****** FIELD CHANGE LETTER ******

PROJECT #: 21-3366.1-A (Lot 134)

LOCATION: Lot 134, Duncan's Creek

PLANS REF: Smithfield Plan (English Country, Garage Left) Project #: 21-3366 (sealed 8-30-24)

206B DIRECT BEAM BEARING
 SD PSL COLUMN NTS

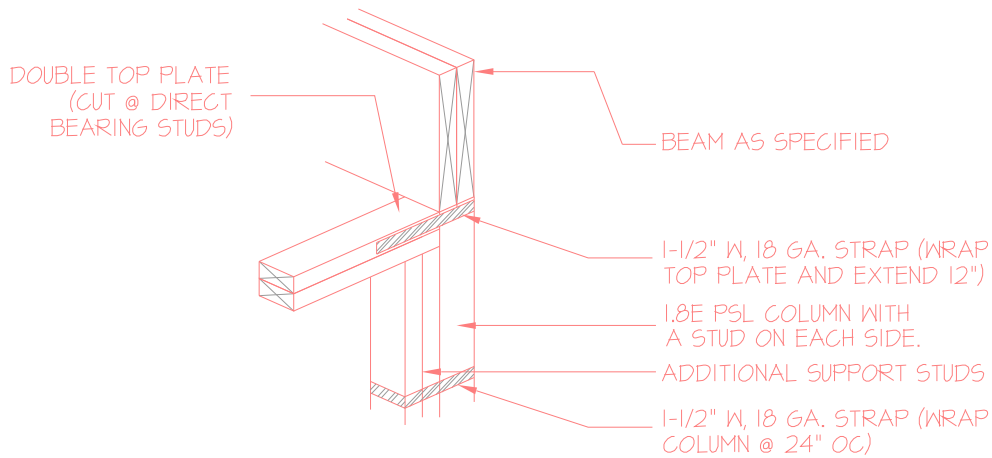
Family Room Wall with Extended Café with Pull-Down Stair Attic: Sheets S-2.1.1 of the plans shows a (3)1.75x16 LVL beam spanning between the Kitchen and the Café. The beam is shown to be supported at the right end by (5)2x6 studs with a 2x6 wall along the rear of the Family Room. (3)2x10 headers with (2) jack studs at each end are shown at the window openings. Based on information provided to Southern Engineers, the rear wall of the Family Room was framed with 2x4 studs @ 12" O.C. (2)2x10 headers with (2) jack studs at each end were installed at each window. The right end of the (3)1.75x16 LVL was supported by a column of (2)2x6 and (3)2x4 studs.

Response: Please note that the above described framing at the rear wall of the Family Room will be structurally acceptable provided that the right end of the (3)1.75x16 LVL is supported on a 3.5"x7" PSL or Glulam column instead of the existing column. The (3)1.75x16 LVL shall be supported directly on the end of the PSL or Glulam column per detail 206B/SD shown on sheet two of this letter.
